IDAP REPORT

Property:	73 Newton Road STRATHFIELD Lot 29 DP 12714 DA2021.162
Proposal:	Demolition of all structure on the site and construction of a proposed two storey dwelling over basement car park and proposed swimming pool and associated external landscape works
Applicant:	Design Link Australia
Owner:	N Said & N Said
Date of lodgement:	15 July 2021
Notification period:	21 July 2021 to 6 August 2021
Submissions received:	Nil
Assessment officer:	G I Choice
Estimated cost of works:	\$2,769,926.00
Zoning:	R2-Low Density Residential - SLEP 2012
Heritage:	No
Flood affected:	No
RECOMMENDATION OF OFFICER:	APPROVAL

Figure 2: Proposed basement plan

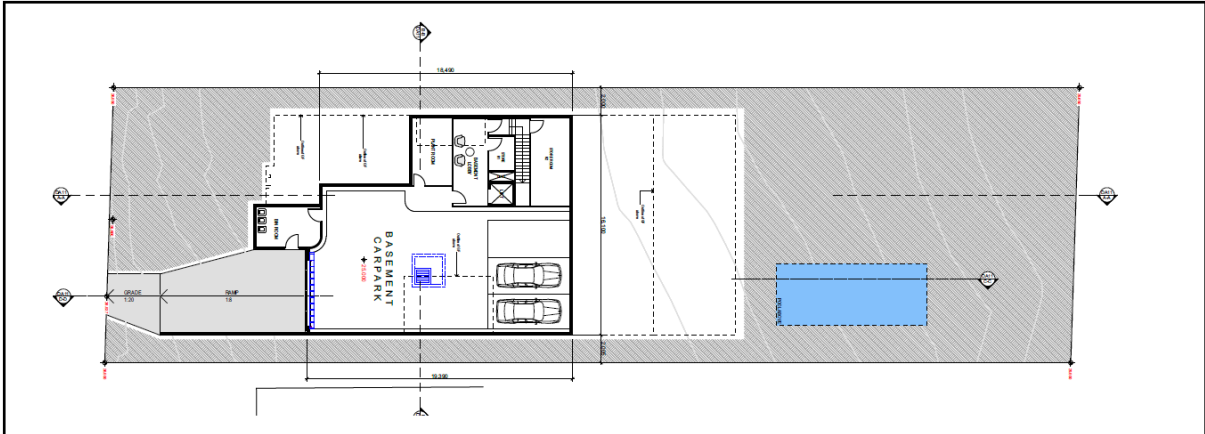
Basement entrance does not comply with SCDCP 2005 width of 3.5 metres and basement area extends beyond the ground level footprint above.

The excavation for the basement bin room extends beyond the footprint of the ground floor above. A condition is imposed requiring the basement plan to be amended so that the entire basement area is limited to and contained within the footprint of the dwelling at ground level. Subject to this appropriate condition, the proposed works will be unlikely to disrupt or effect existing drainage patterns or soil stability in the locality or effect the future use or development of the land. It is unlikely to effect the existing and likely amenity of adjoining properties and there is no potential for adverse impacts on any waterways, drinking water catchment or environmentally sensitive areas. The proposed excavation works are considered to satisfactorily address the objectives of this clause.

A condition is imposed requiring a reduction of the basement footprint to fit wholly within the ground level footprint above, ensuring that cut and fill is kept to a minimum and existing ground levels will be maintained where appropriate to reduce site disturbance. Existing trees and shrubs have been retained where possible and ground water tables are maintained and impact on overland flow and drainage is minimised.

Amendments made in red on approved plans	All changes made in red on the approved plans shall be updated and shown on the Construction Certificate plans.
Driveway/ basement entrance width	The vehicular access driveway width must be reduced from the proposed 6.1 metres to 3.5 metres to achieve a maximum allowed width. Any front fence or gate opening adjustments required as a result of this reduction must be illustrated on the plans lodged with the application for the Construction Certificate.
Basement Plan	<p>The Basement Plan shall be amended so that the entire basement area is limited to and contained within the footprint of the dwelling at ground level. The amended basement plan shall be submitted to the Principle Certifying Authority for approval prior to the issue of any Construction Certificate.</p> <p>Note: External patios, courtyards, alfresco areas etc. are excluded from the dwelling footprint.</p>

Figure 6: Proposed north & south elevations

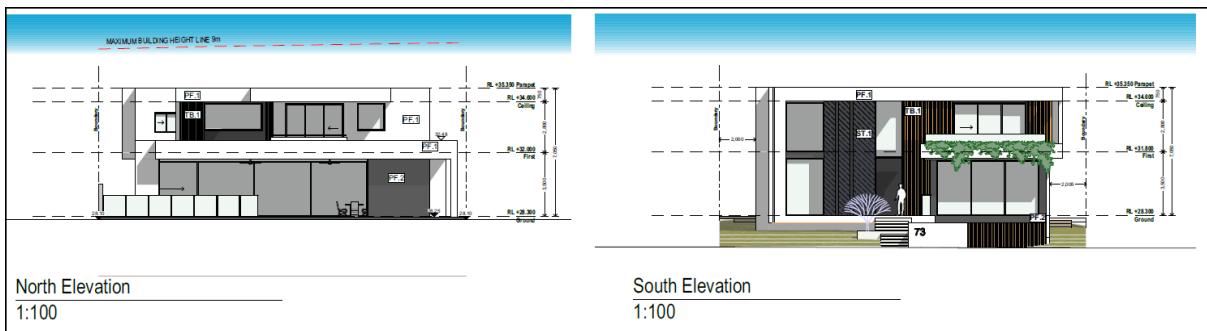
The front façade provides sufficient modulation and articulation to minimise visual impacts to the existing streetscape, however, the proposed basement ramp entrance width at 6.1m is considered to be unacceptable as it will dominate the streetscape. A condition is imposed requiring a design change to reduce the basement entrance width to 3.5m
